## **ATTACHMENT 1**

### **Responses to NRC Requests for Additional Information (RAIs) on WCAP-17096-NP, Rev. 3**

### CE-ID: 1 Core Shroud Assembly (Bolted) - Core Shroud Bolts

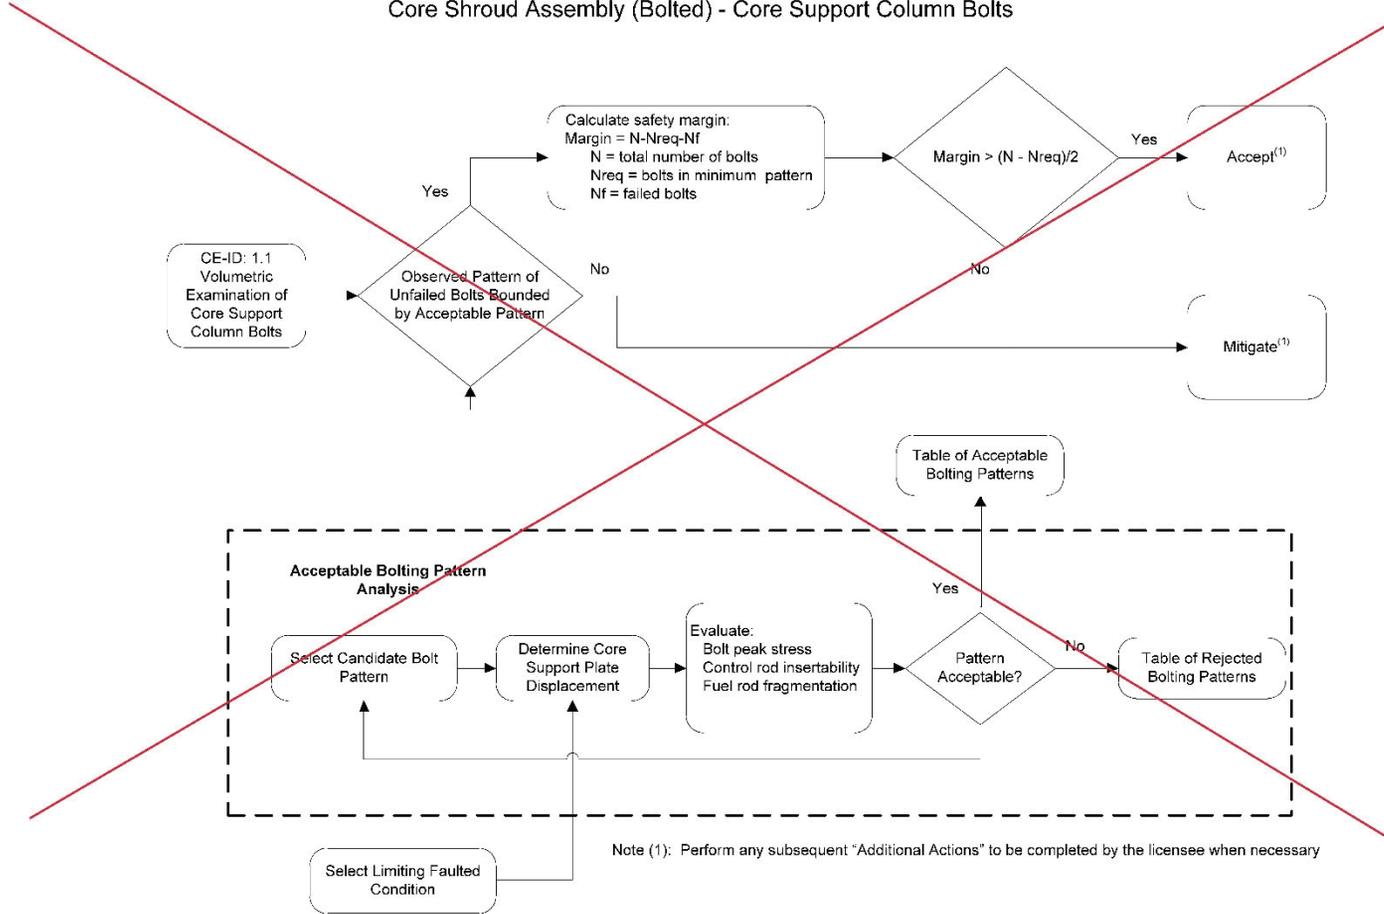
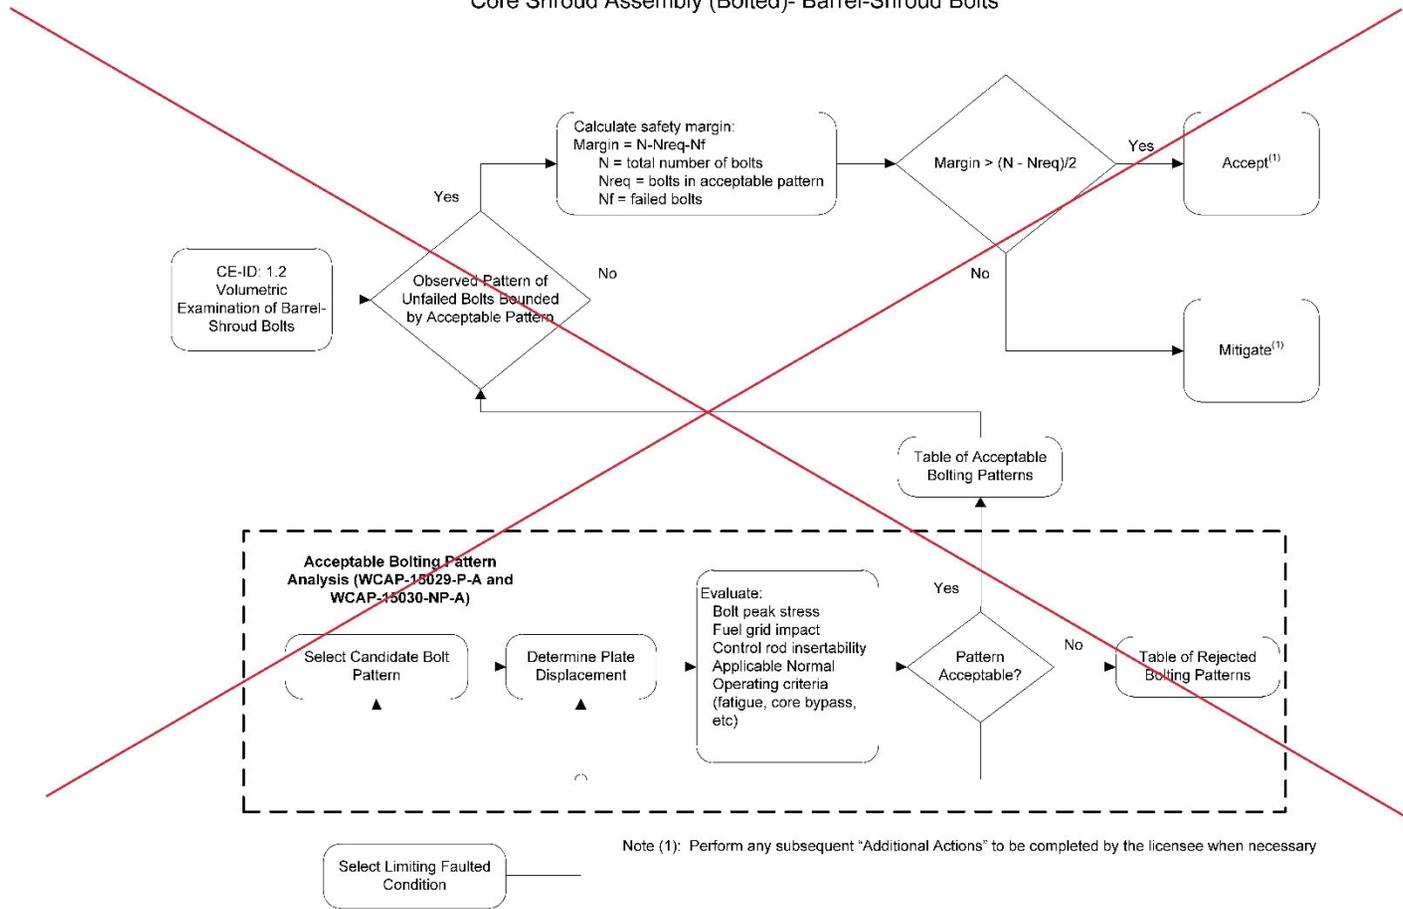
The first emphasized statement in the above paragraph is not consistent with component evaluation methods specified in TR Appendix C for CE bolted core shroud assemblies, core shroud bolts (CE-ID Item 1) and barrel-shroud bolts (CE-ID Item 1.2). These CE-ID items cite the original acceptable bolting pattern analysis (ABPA) methodology in WCAP-15029-P-A, Rev. 1 (1999). WCAP-15029-P-A, Rev. 1 is identified as an ABPA methodology for baffle-former bolting and barrel-former bolting in WEC-designed reactors. The WCAP does not provide methods for performing ABPAs for core shroud bolting and barrel-shroud bolting in CE-designed reactors.

- (a) Explain how CE-ID Items 1 and 1.2 are eligible to use the methodology in WCAP-15029-P-A, Rev. 1. If it can be adequately demonstrated that WCAP-15029-P-A, Rev. 1 is an acceptable ABPA method for these CE components, then please revise TR Section 3.3 to state this. Otherwise, please delete the citation of the WCAP-15029-P-A for these CE items, and replace it with a more generic method for bolted core support structures, such as ASME Section III, Subsection NG and applicable ASME Section III Appendices, Code Cases, etc.

- (a) The applicability of the baffle-former bolt evaluation methodologies in WCAP-15029-P-A [18] and WCAP-15030-NP-A [19] is for Westinghouse NSSS plants. Only two CE NSSS plant designs have the bolted baffle-former assembly design similar to the Westinghouse NSSS plant designs: Fort Calhoun and Palisades. Fort Calhoun shutdown in October 2016, and Palisades is scheduled to shutdown in the Spring of 2022. Therefore, the methodologies in CE-ID: 1 and 1.2 will not be utilized in the future, and CE-ID: 1 and CE-ID: 1.2 will be removed from the TR. In addition, CE-ID: 1.1 for the Core Support Column Bolts will be removed, although WCAP-15029-P-A was not included, since this methodology would only apply to NSSS plant designs with bolt baffle-former assemblies.

These changes are shown by the removal of CE-ID: 1, CE-ID: 1.1, and CE-ID: 1.2 from the list of CE components on page 7 of Attachment 2, in the removal of CE-ID: 1 for Core Shroud Bolts on pages 8 and 9 of Attachment 2, in the removal of CE-ID: 1.1 for Core Support Column Bolts on pages 10 and 11 of Attachment 2, and also in the removal of CE-ID: 1.2 for Barrel-Shroud Bolts on pages 12 and 13 of Attachment 2. The flowcharts for CE-ID: 1, CE-ID: 1.1, and CE-ID: 1.2 were removed as shown on pages 18-20.
